DRAFT Planning Commission Motion NO. M-XXXX

Hearing Date: March 23, 2017
Case No.: **2014-000362ENV**
Project Address: **1500 Mission Street Project**
Zoning: C-3-G (Downtown General Commercial) District
Van Ness & Market Downtown Residential Special Use District
120/320-R-2, 85/250-R-2, 85-X Height and Bulk Districts
Block/Lot: 3506/002, 003¹
Lot Size: 110,772 square feet (2.5 acres)
Project Sponsor: Goodwill SF Urban Development, LLC
Related California Urban Housing
Matthew Witte, (949) 697-8123
mwitte@related.com
Lead Agency: San Francisco Planning Department
Staff Contact: Michael Li – (415) 575-9107
michael.j.li@sfgov.org

DATE: **March 9, 2017**
TO: Members of the Planning Commission and Interested Parties
FROM: Lisa M. Gibson, Acting Environmental Review Officer
Re: **Attached Responses to Comments on Draft Environmental Impact Report:
Case No. 2014-000362ENV for the 1500 Mission Street Project**

Figure RTC-1
Recently Adopted Area Plans In and Near the
1500 Mission Street Project Site Vicinity

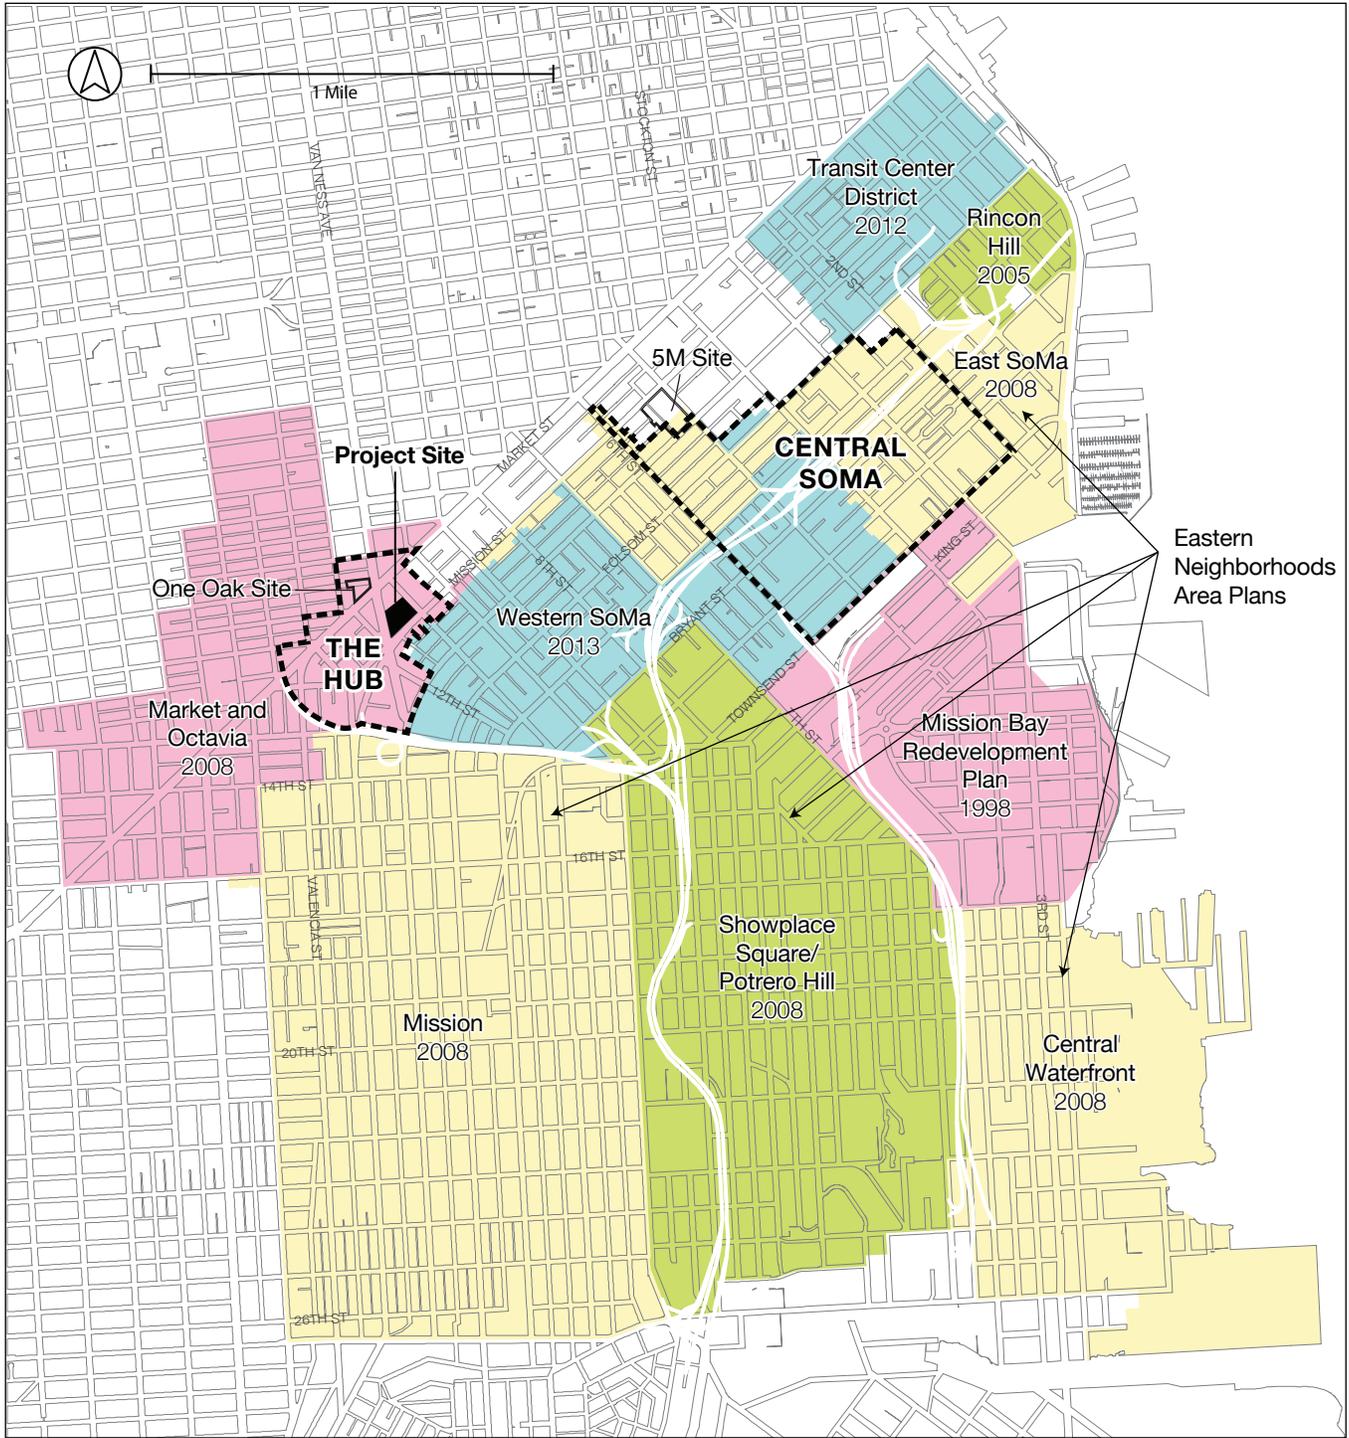
“Two maps must be added to 1500 Mission DEIR

“A map showing the boundaries of the **Market/Octavia Area Plan** PLUS the boundaries of the **Eastern Neighborhoods Area Plan** with its **5 sub-area Plans** (including the **Western SoMa Area Plan**). The M/O plan should show sub-area Van Ness & Market Downtown Residential Special Use District.

“Superimpose on this Map the boundaries of the **proposed Central SoMa Area Plan, The Hub**, and all other Plans that have amended these Area Plans. This would include the **5M plan** at 5th & Market which amended part of the Eastern Neighborhood Area Plan. PLUS any **proposed** Map Amendments to either Market/Octavia or the Eastern Neighborhoods Plan, including those proposed in any pending PPA [Preliminary Project Assessment]. This is the proposed map amendment for One Oak/1500 Market. Also the requested height reclassification on the western end of One Oak/1500 Market block - at Franklin & Oak.

The comment requests further information, including a map, concerning recent planning efforts in the project vicinity, including those for the Market & Octavia area, Eastern Neighborhoods, and Western SoMa, to provide context for the proposed project.

Figure RTC-1, Recently Adopted Area Plans in and near the 1500 Mission Street Project Site Vicinity, page RTC-14, depicts the recently adopted area plans, including the Market & Octavia Area Plan (adopted in 2008), the four Eastern Neighborhoods plans (Mission, Showplace Square/Potrero Hill, Central Waterfront, East SoMa) (adopted in 2008), the Western SoMa Plan (adopted in 2013), Rincon Hill Plan (updated plan adopted in 2005), and Transit Center District Plan (adopted in 2012). The figure also shows the area of the proposed Central SoMa Plan and the area covered by the proposed Hub planning effort. The nearby-proposed One Oak Street Project (1500–1540 Market Street; Case No. 2009.0159E) site is also shown, as is the approved 5M Project site. Each of these plans contains parking maximums, rather than parking minimums.

Figure RTC-7
Proposed Wind Screen (detail of Draft EIR Figure II-16)

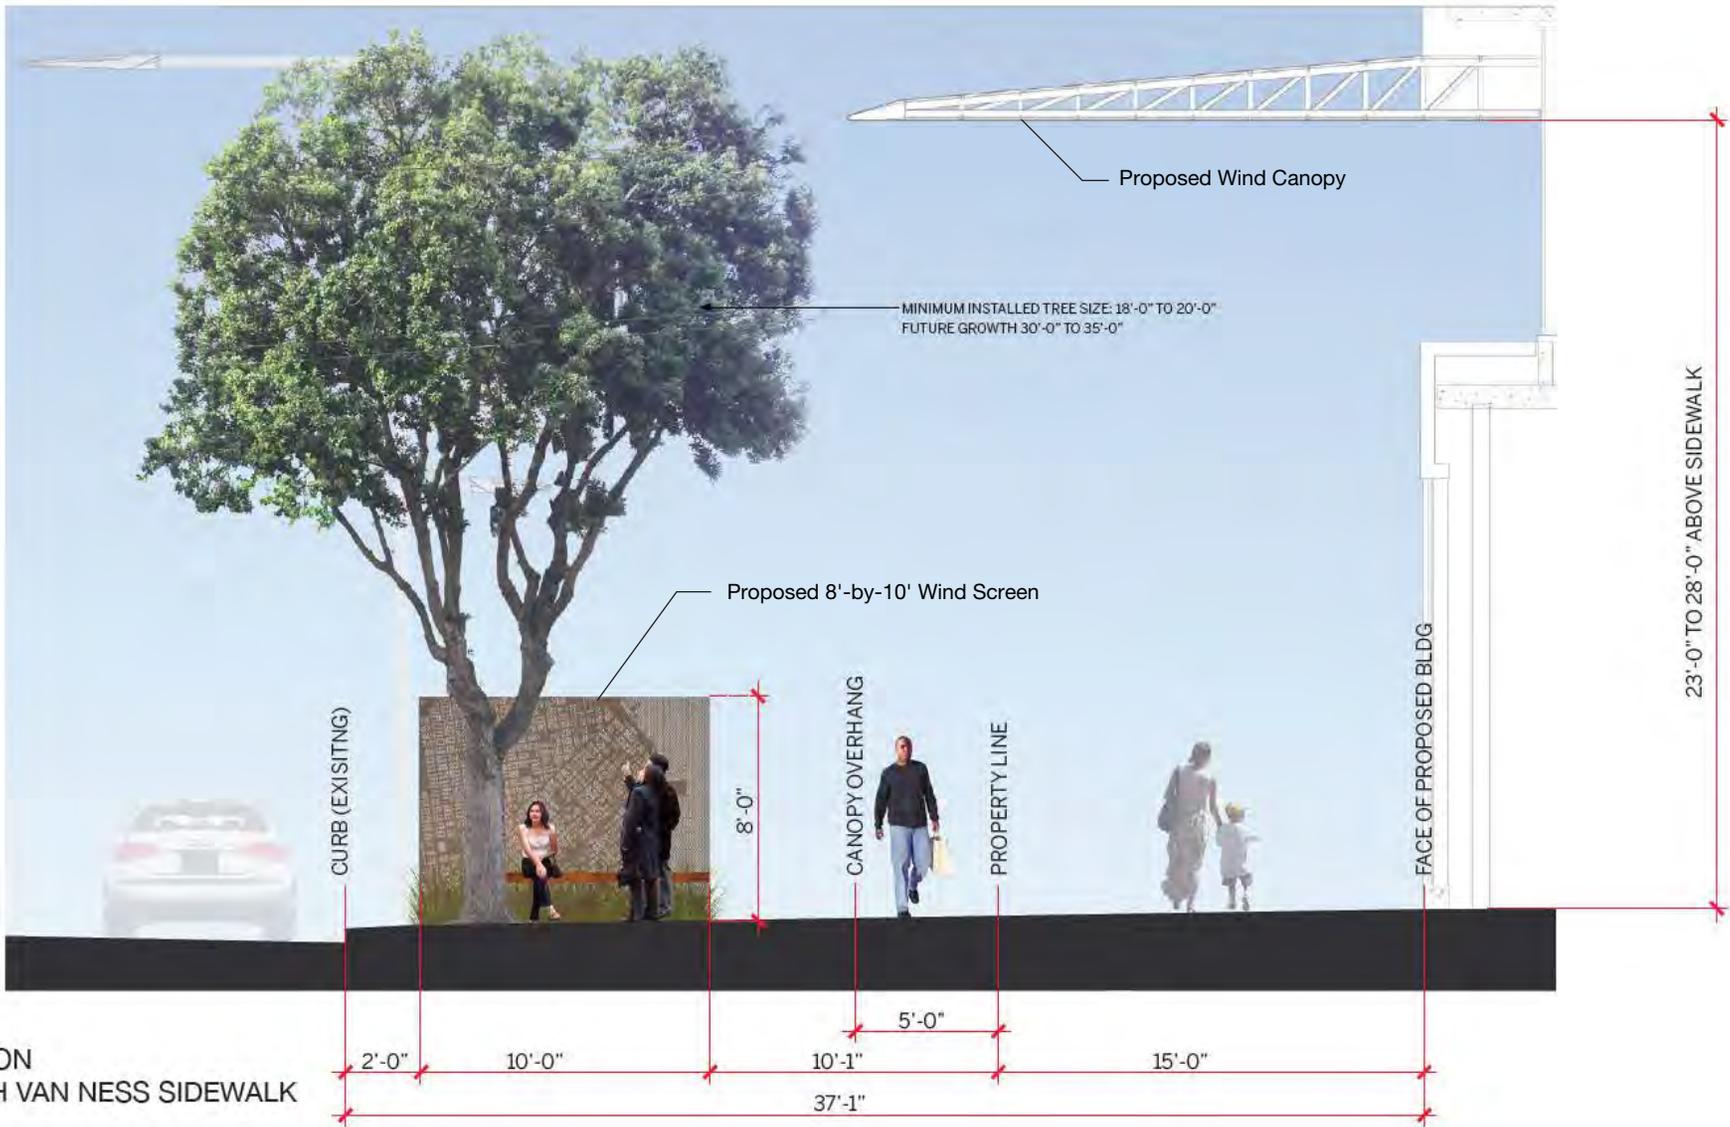
“Please explain and show on visual - **Figure II-16 - the proposed wind screens**. They are hard to understand/see.” (Sue C. Hestor; letter, January 4, 2017)

As stated on Draft EIR page II-23, as revised herein, and illustrated in Draft EIR Figure II-16, Draft EIR page 26, as well as in **Figure RTC-7, Proposed Wind Screen (Detail of Draft EIR Figure II-16)**, page RTC-56, herein, the proposed project would include a wind canopy that would surround the South Van Ness and Mission Street façades of the project’s residential tower at a height of between about 23 and 28 feet above the sidewalk. The wind canopy would be 20 feet wide on South Van Ness Avenue and 14 feet, 9 inches wide along Mission Street. It can be expected that the wind canopy, in addition to protecting pedestrians on the sidewalks surrounding the residential tower, would tend to slow winds and disperse them away from the tower. This is because wind effects of buildings result in relatively higher-speed winds at higher elevations being intercepted by the building and channeled down and around the building walls, accelerating as they descend. Anything that interrupts the flow of the wind rushing down the side of the building will result in lower ground-level wind speeds. This is why towers that are set back from building street walls tend to result in calmer wind conditions at the building base than buildings whose street walls are uninterrupted. The proposed project’s wind canopy would function much as a setback, resulting in lower wind speeds outboard from the canopy (as at the base of a building street wall with a setback tower above), including where a bicycle lane is planned on Mission Street (see below), as well as beneath the canopy, where the canopy would provide direct protection to pedestrians.

As described on Draft EIR page II-25, the proposed project would include “the installation of eight wind screens approximately eight feet tall by 10 feet wide at 40-foot intervals along the South Van Ness Avenue sidewalk adjacent to the project site and perpendicular to the street.” A typical wind screen, anticipated to be approximately 50 percent porous, is illustrated in the top image of Draft EIR Figure II-16, Draft EIR page 26. The wind screens are also visible in Figure II-22, Draft EIR page 35, which presents a view of the proposed project from South Van Ness Avenue. **Figure RTC-7, Proposed Wind Screen (Detail of Draft EIR Figure II-16)**, page RTC-56, and **Figure RTC-8, View of Proposed Wind Screens along South Van Ness Avenue (Detail of Draft EIR Figure II-22)**, page RTC-58, present enlargements of portions of Draft EIR Figure II-16 and Figure II-22 to more clearly depict the proposed wind screens.
